UNITED STATES
NUCLEAR REGULATORY COMMISSION
WASHINGTON, D. C. 20555

March 16, 1988

TRIP REPORT RE: CONTAINMENT VENTING AT NINE MILE POINT 1
AND SUSQUEHANNA 1 & 2

SUPPLEMENTARY INFORMATION FOR TRIP REPORT ON
INSPECTION OF CONTAINMENT VENTING
PROCEDURES AT NINE MILE UNIT 1 AND SUSQUEHANNA UNITS 1&2

FIGURE 1 ..
 SIMPLIFIED DIAGRAM
 CONTAINMENT PURGE, COOLING, AND VENTILATION

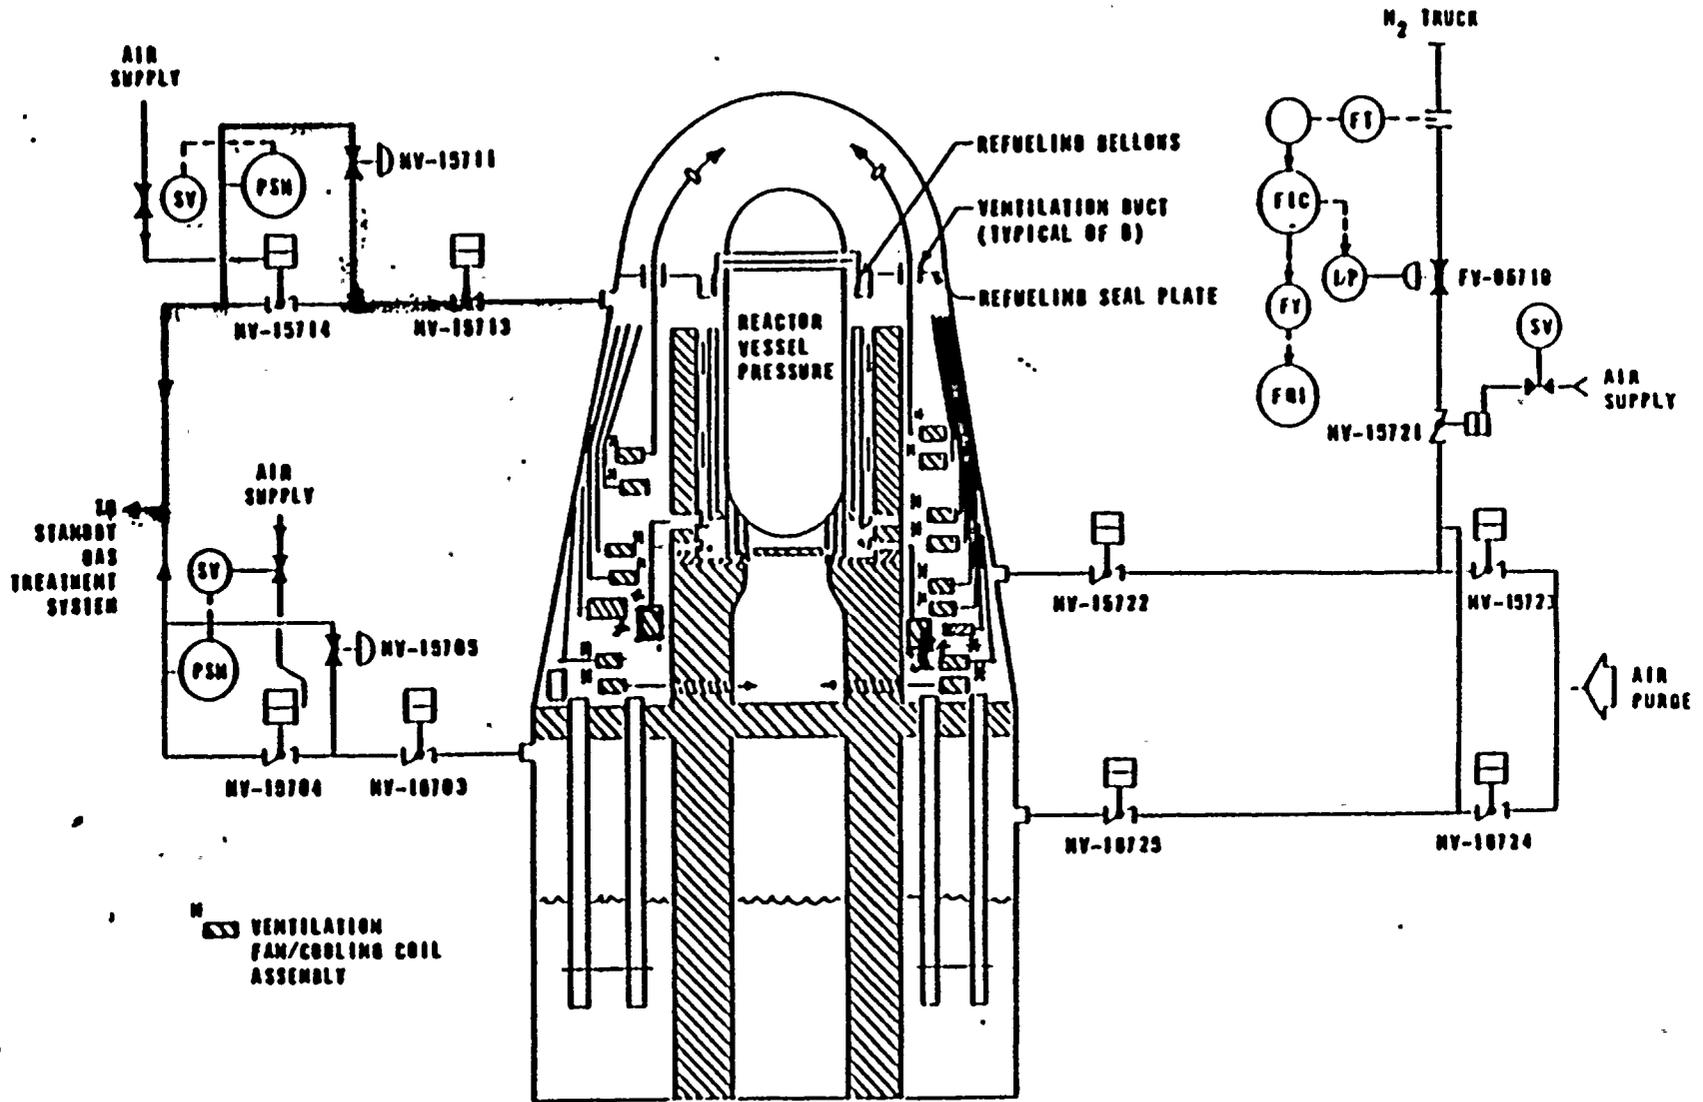
Unlike NMP-1 the SSES at present does not have much of the equipment needed for effective use of venting to mitigate over-pressure and hydrogen burn challenges to the containment for those accident sequences when the containment pressure is likely to be high (greater than 20 psig). Although the plant has containment isolation valves (in the 24 inch drywell vent line and 18 inch torus vent line), which are qualified for design basis LOCA containment pressure and environment, the plumbing between these valves and the external vent release point is via the SGTS and consists of duct work which is unlikely to withstand pressure above 10 psig. Opening these valves during severe accidents, when the containment may reach design pressure (53 psig), will certainly fail the duct work and release steam, hydrogen and noble gases from the primary containment to the reactor building (secondary containment). The releases in the secondary containment may preclude availability of some unfailed safety equipment and complicate post-accident recovery efforts involving operator entry to use that equipment. Moreover, the vent release to the atmosphere is located on the roof of the reactor building and any releases of noble gases via this vent path would behave like ground level releases outside the reactor building, if the duct work survives the venting pressures. SSES purge and vent containment isolation valves' handwheels have been removed to prevent inadvertent manual operation. However, these air operated valves can be operated via manual local air connections. The venting study indicates that Station Blackout (SBO) sequences dominate the core melt frequencies. Therefore, for venting to be effective under risk-dominant accidents, manual operation via local air connections of the containment isolation valves will be necessary. This can be achieved by relatively minor modifications to provide protection against severe radiation environments expected in the vicinity of these valves during severe accidents involving core damage (SSES valves are also separated from the suppression pool by a heavy concrete wall).

FIGURE 2
STANDBY GAS TREATMENT SYSTEM
LOCA INITIATED -

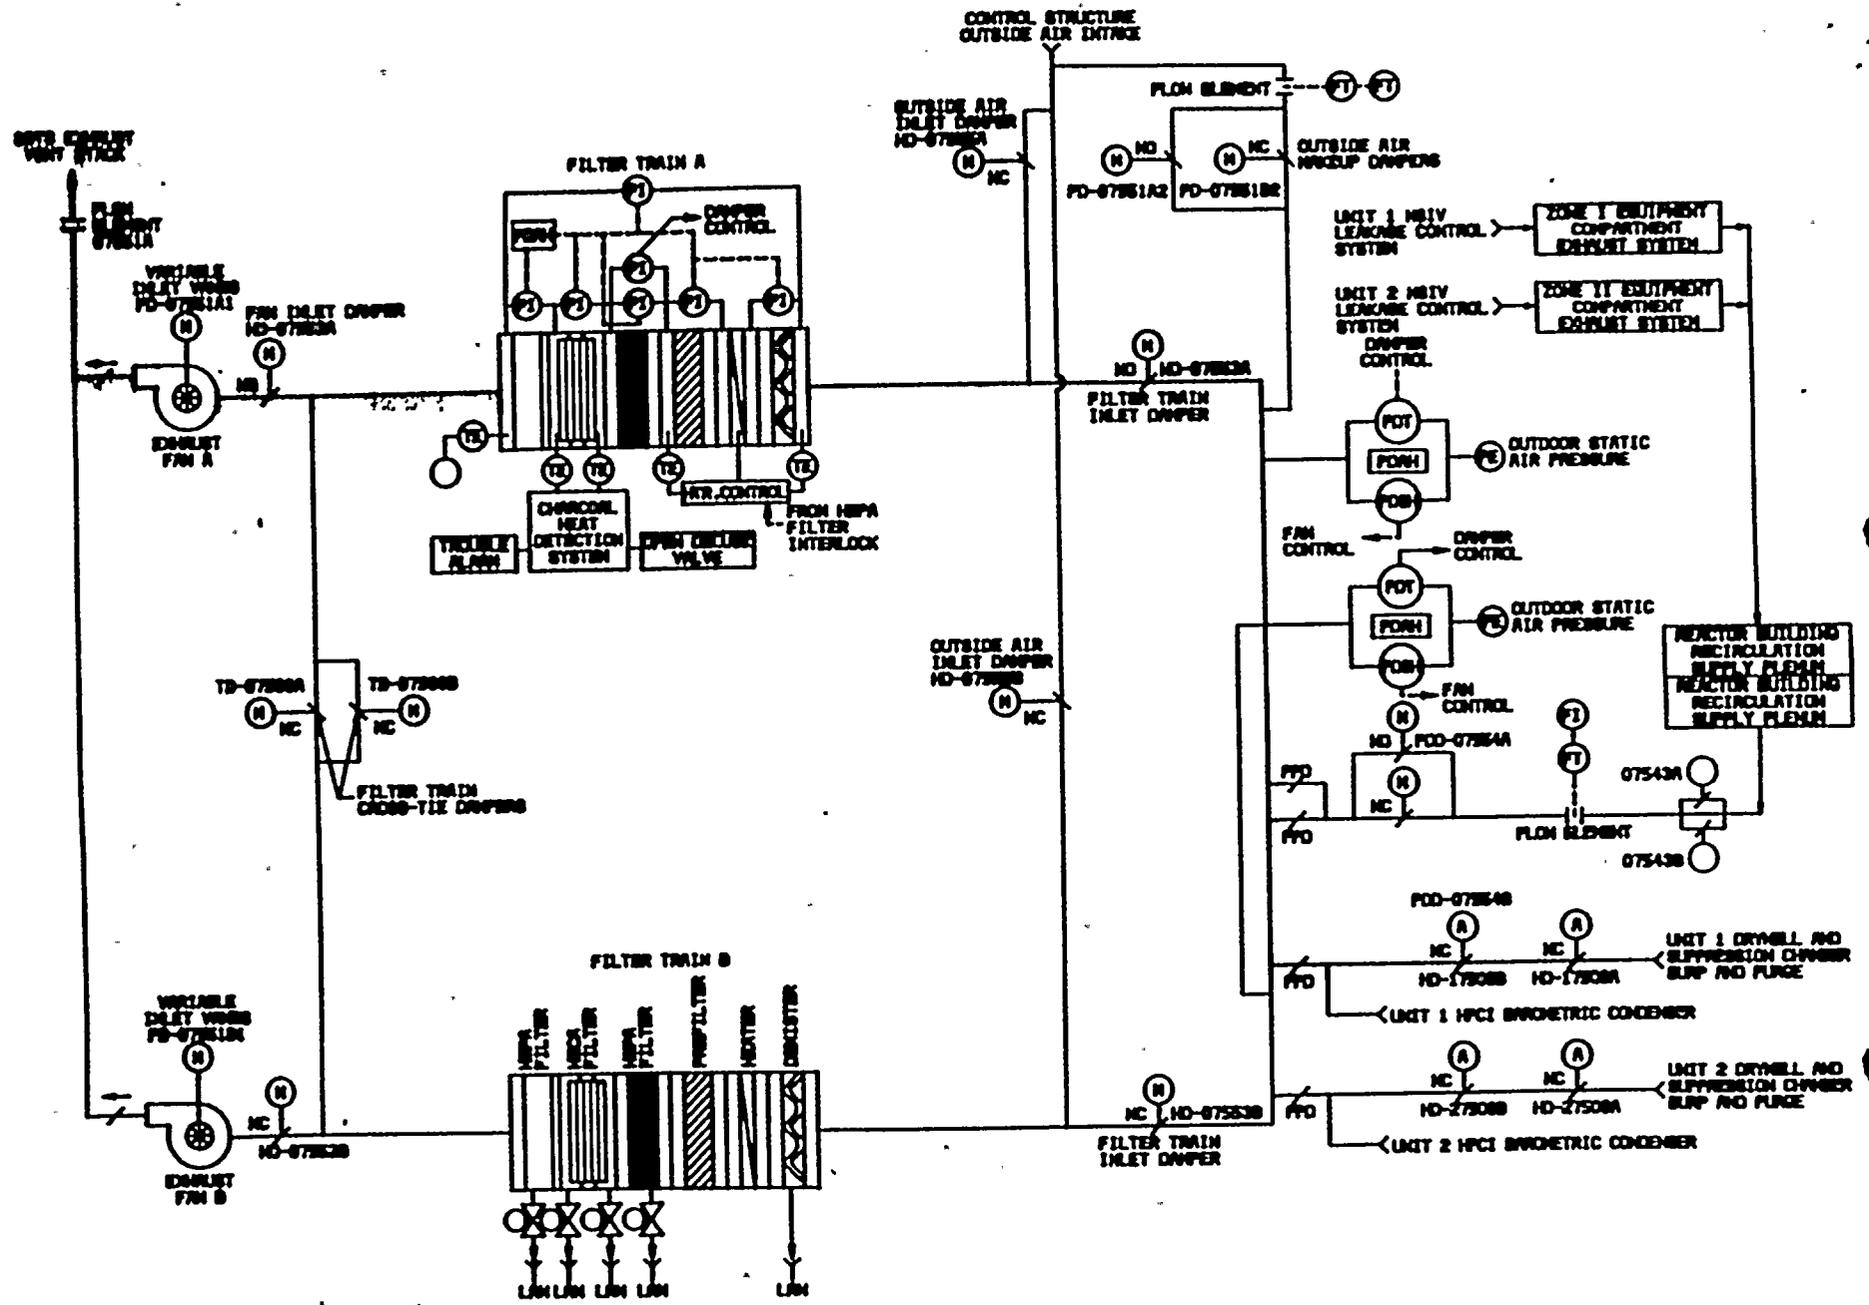
3. During the plant walkdown, the staff observed the location of several components that would be activated during containment venting. When asked if an air-operated valve (HV-15703) in the SGTS could be operated, if required under accident conditions, the licensee indicated that there is a possibility that this particular valve might become inaccessible to operators because of the potential for high levels of radiation existing in the vicinity of the valve (it is near the drywell) during some emergency conditions.
